ADDRESSEES	: ABC Customer Care and Parts Source Owners and operators of vehicles mentioned under "Application"
VEHICLE TYPE	: CX45 and TX45 with Detroit Diesel DD13 EPA2016 engine
CONFIGURATION GROUP	: 2.22 Traction engine – Air intake system
BULLETIN TYPE	: Service Information
DATE	: November 29th, 2017
SUBJECT	: To check security of engine air intake pipe bracket
CONDITIONS	: This service bulletin does not entitle to any reimbursement.

Figure 2

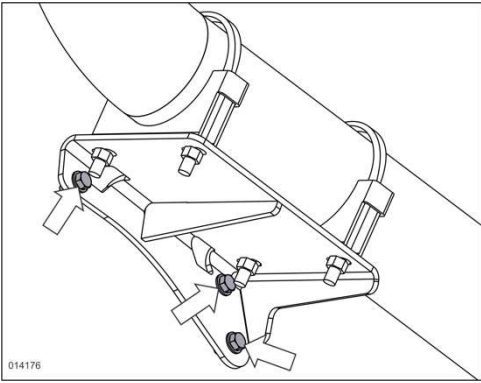
It has been determined that on a number of vehicles the engine air intake bracket (refer to figure 1 for location of bracket) is possibly not properly secured to the engine. Due to production tolerances, the 25 mm (1 inch) long screws can bottom out before the screw head is tight against the bracket.

Step	Action
1	Open the engine compartment rear access door.
2	Check the security of the bracket.
3	Add M8 washers under the screw heads as needed, to make sure that the screw does not bottom out. Tightening torque: 14.5 ft.lbf (21 Nm). 
4	Re-check the security of the bracket.
5	Close the engine compartment rear access door.
